From: [Orlaith Nihill](#)
To: [SIDS](#)
Subject: Ref: 320705 - Further Information Response
Date: Wednesday 5 August 2026 17:17:02
Attachments: [320705_FurtherInformationResponse_OrlaithNihill.pdf](#)

Re: ABP – PA03.320705

Planning Permission to develop a Windfarm and Ancillary Infrastructure located in the townlands of Snatty, Hurdlestown, Oatfield, Drumsillagh, Sallybank, Gortacullin, Aharinaghbeg, Knockshanvo, Cloontra, Cloghoolia, Ballycullen and others, County Clare. And located in the townland of Court, County Limerick.

Drawing Title
Roost Records

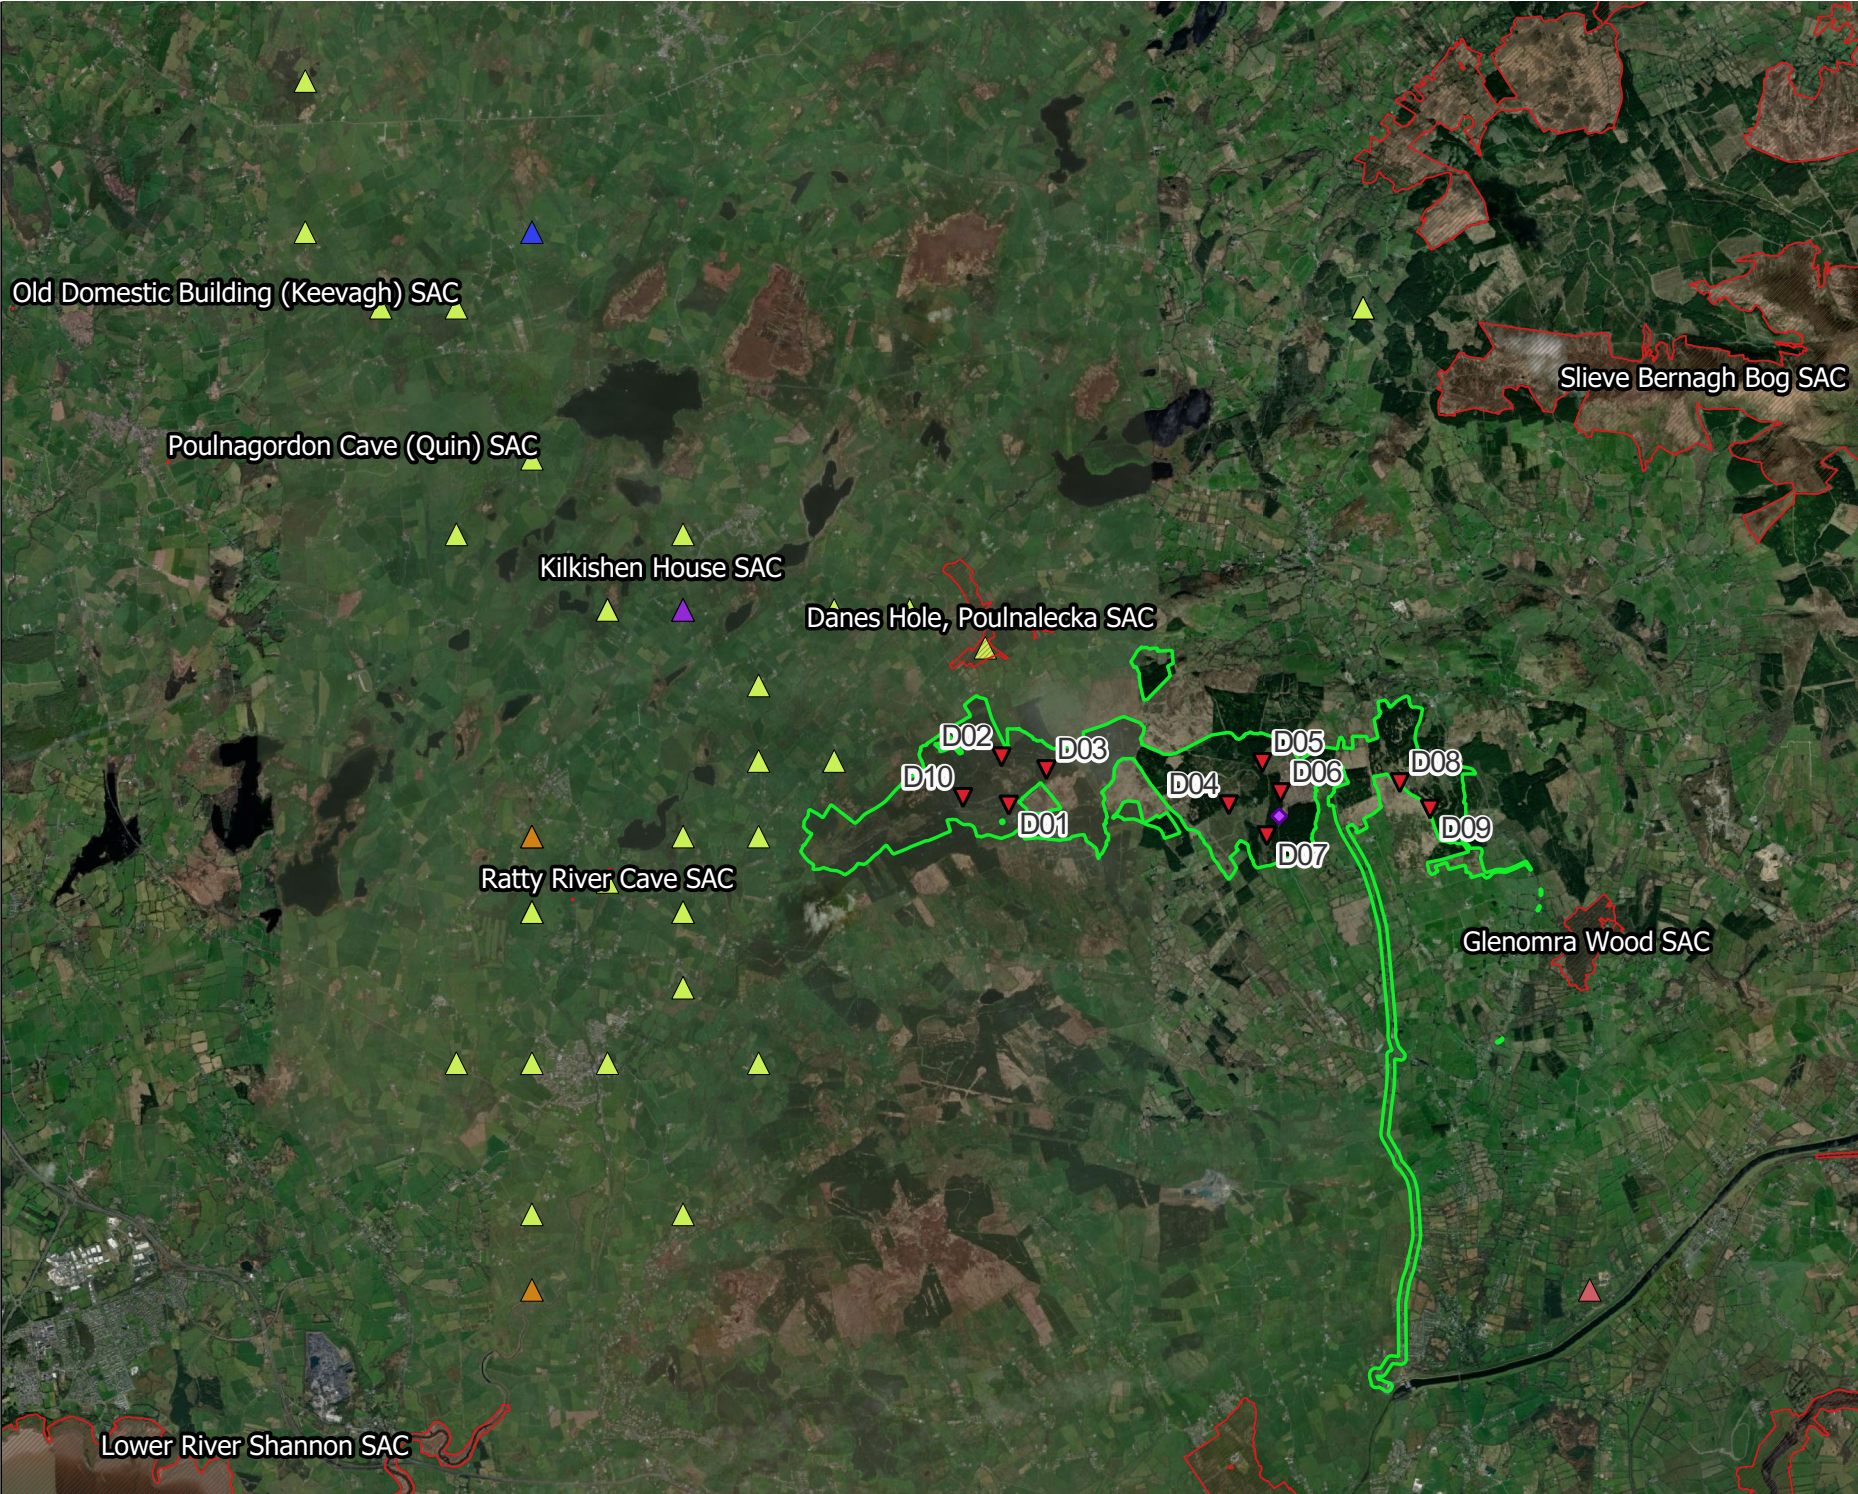
*'The Proposed Development Site is located within 2.5km of two lesser horseshoe designated SACs, Ratty River Cave SAC [002316] and Danes Hole, Poulanecka SAC [000030]. In addition, **seven roosts, including two large summer roosts of which at least one maternity roost, were recorded within 2.5km of the Site and provided as confidential records by NPWS. Other roosting sites located within 2.5km of Knockshanvo Wind Farm include day roosts and transitional roosts.**'* [Emphasis Added]

Fig. 3-2 'Roost Records' shows all the lesser horseshoe roosts (*Rhinolophus hipposideros*) and has been attached for ease of reference at the end of this submission.

Taking into account all of the lesser horseshoe bat roosts that fall within this distance, including two designated SAC's and the sentiment expressed in 'The Lesser Horseshoe Bat Species Action Plan 2022 – 2026' referred to above, there is substantial doubt raised as to the validity of this conclusion reached in the Natura Impact Statement.
